REMARKS

Serial No. 09/888,400

Marked-Up Version of Changes Made

HANA 2001-P-31
FIG. 1a

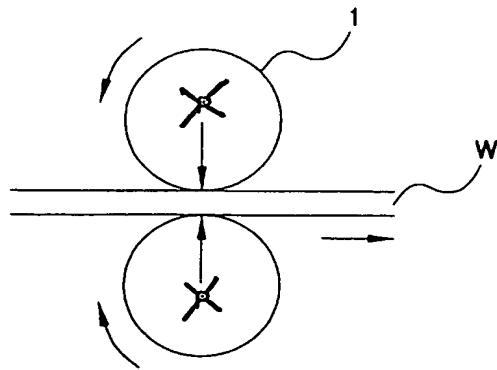
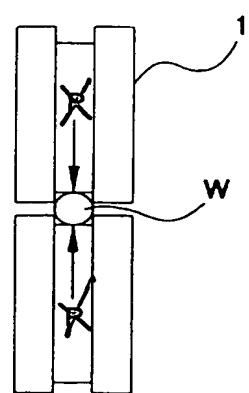
the residual stress deviation in a radial direction of the wire W becomes greater. This results in a greater difference of hardness between one outside and the other outside of the wire W. As a consequence, the wire W is twisted if it fails to resist continuous partial load (refer to Figs. 1A and 1B) laid thereon when the wire W passes through a feeding roller in the course of welding, thereby resulting in vibration of the tip of the wire W that might cause an arc instability. Further, [when the contact area of the portion where the wire W is actually reduced is excessively large] when there is excessively large the diameter reducing contact part 20 for actually reducing the diameter of the wire W, a partial work hardening occurs, thereby lowering the quality of surface of the wire W. In the worst case, the partial stress deviation between the inside (central portion) and outside of the wire W becomes greater, thereby disabling drawing of the wire W.

Fig.2

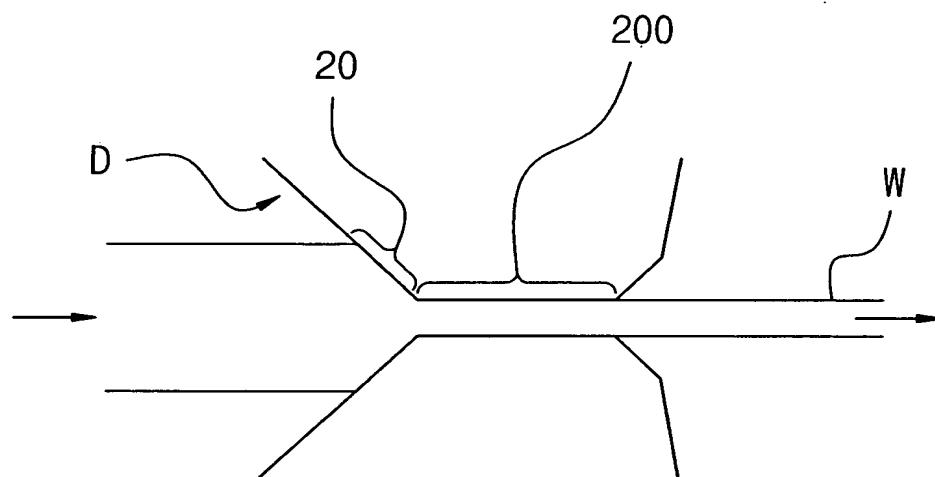
Fig. 2 is a diagram illustrating [a reducing contact area 20 and a correction contact area 200 when a wire W passes through dies D] a diameter reducing contact part 20 for reducing a diameter of a wire W and a diameter correcting contact part 200 (a bearing part) for correcting the diameter of the wire W when the wire W passes through die D.
